DEVELOPMENT APPLICATION ASSESSMENT REPORT

Application Number:	DA2021/2304		
Responsible Officer:	Stephanie Gelder		
Land to be developed (Address):	Lot 15 DP 708369, 71 Haigh Avenue BELROSE NSW 2085		
Proposed Development:	Alterations and additions to a dwelling house		
Zoning:	Warringah LEP2011 - Land zoned R2 Low Density Residential		
Development Permissible:	Yes		
Existing Use Rights:	No		
Consent Authority:	Northern Beaches Council		
Land and Environment Court Action:	No		
Owner:	Thomas Ritchie Davidson Kylie Anne Davidson		
Applicant:	Leon Varley		
Application Lodged:	07/12/2021		
Integrated Development:	No		
Designated Development:	No		
State Reporting Category:	Residential - Alterations and additions		
Notified:	13/12/2021 to 18/01/2022		
Advertised:	Not Advertised		
Submissions Received:	0		
Clause 4.6 Variation:	Nil		
Recommendation:	Approval

Figure 1. North-West Elevation

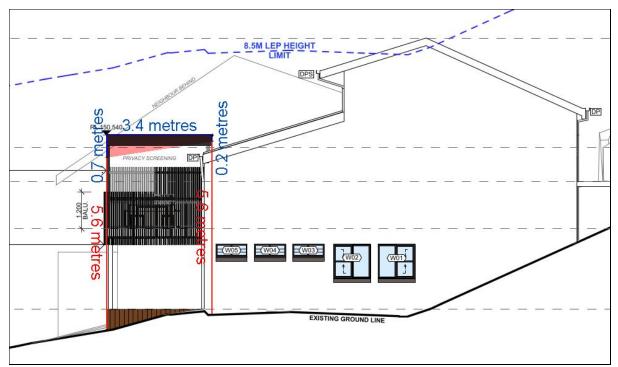
Under Part B3 of Warringah Development Control Plan 2011, buildings must be sited within a building envelope determined by projecting planes at 45 degrees from a height of 4 metres above ground level (existing) at the side boundaries.

The proposal is sited outside of the building envelope on the north-west elevation as depicted in Figure 1. The north-west side of the pergola sits outside of the building envelope for a maximum of 0.7m metres in height for a horizontal length of 3.4 metres, resulting in a variation of 12.5%.

In this instance, whilst the encroachment of the building envelope control is numerically non-compliant, the proposal demonstrates compliance with the objectives of the control as outlined below. Therefore, the variation to the building envelope control is considered to be supportable.
